Enclosure 5 to Serial: HNP-98-188

SHEARON HARRIS NUCLEAR POWER PLANT
DOCKET NO. 50-400/LICENSE NO. NPF-63
REQUEST FOR LICENSE AMENDMENT
SPENT FUEL STORAGE

TECHNICAL SPECIFICATION PAGES

Figure 5.6.1: Burnup Versus Enrichment for PWR Fuel

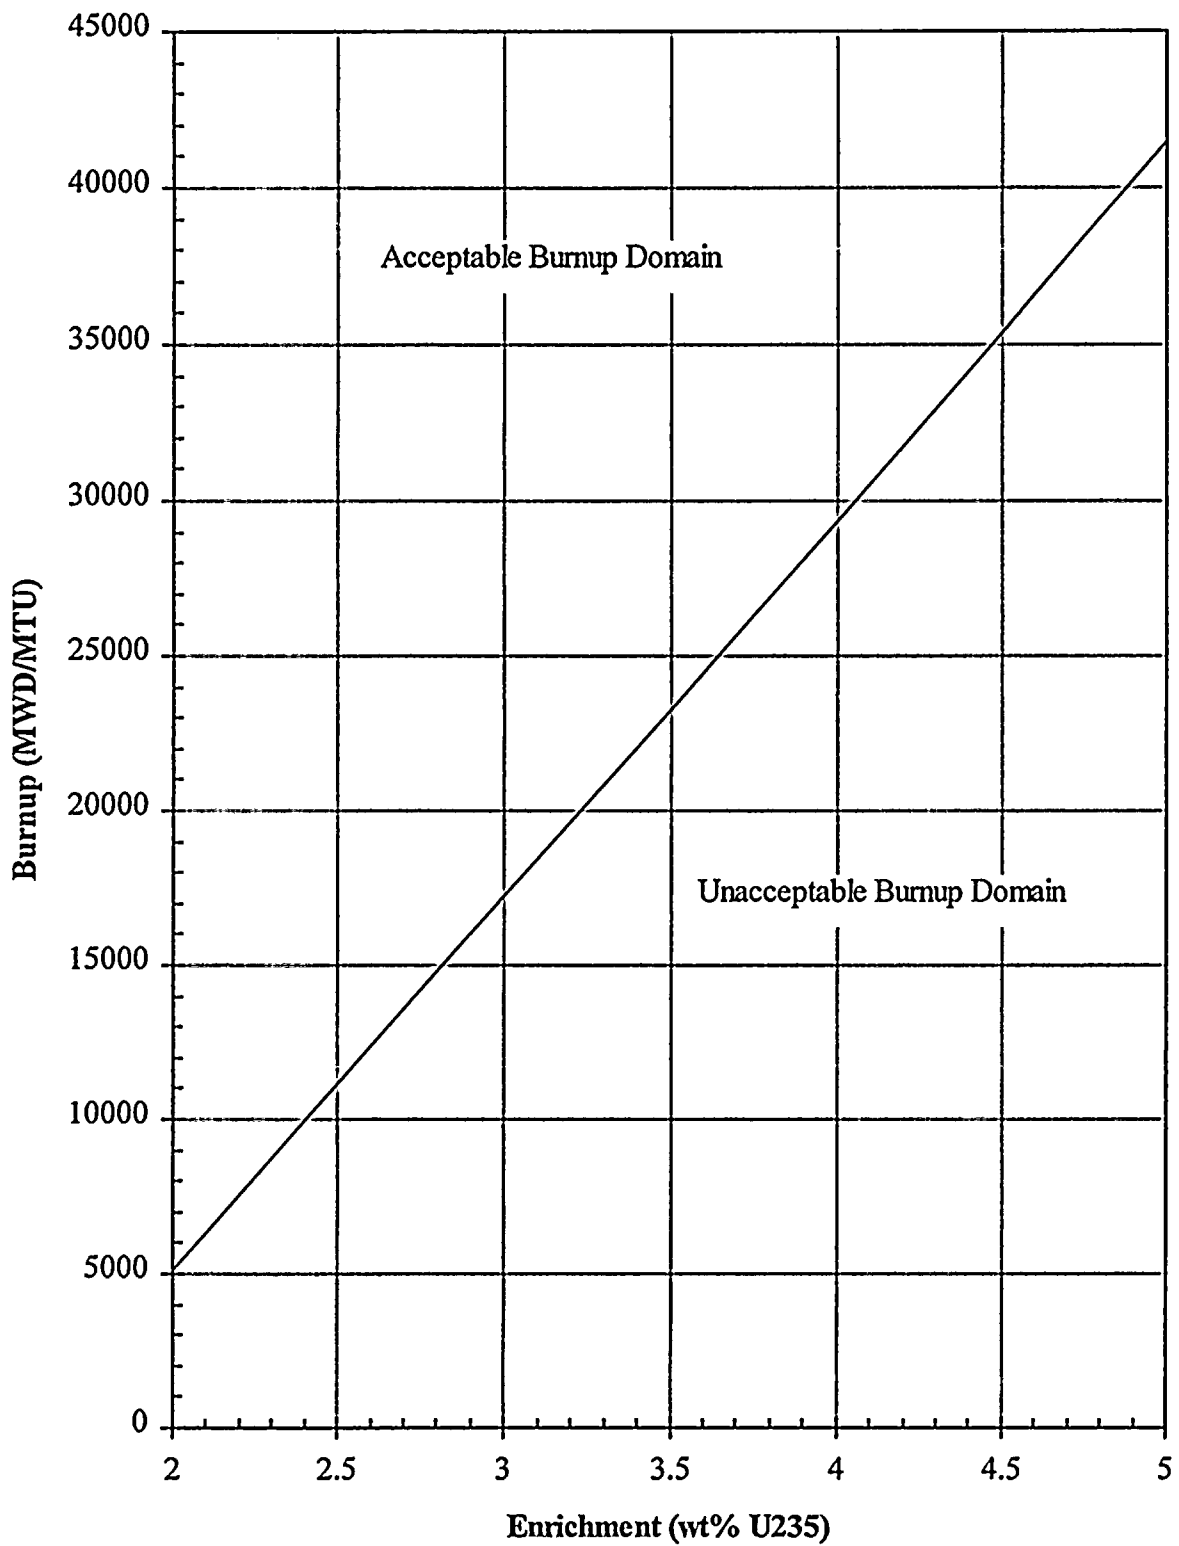
- a. PWR assemblies must be within the "acceptable range" of the burnup restrictions shown in Figure 5.6.1 prior to storage in Pools 'C' or 'D'
 - b. BWR assemblies are acceptable for storage in Pool 'C' provided that the maximum planar average enrichments is less than 4.6 wt% U235 and K_{inf} is less than or equal to 1.32 for the standard cold core geometry (SCCG).
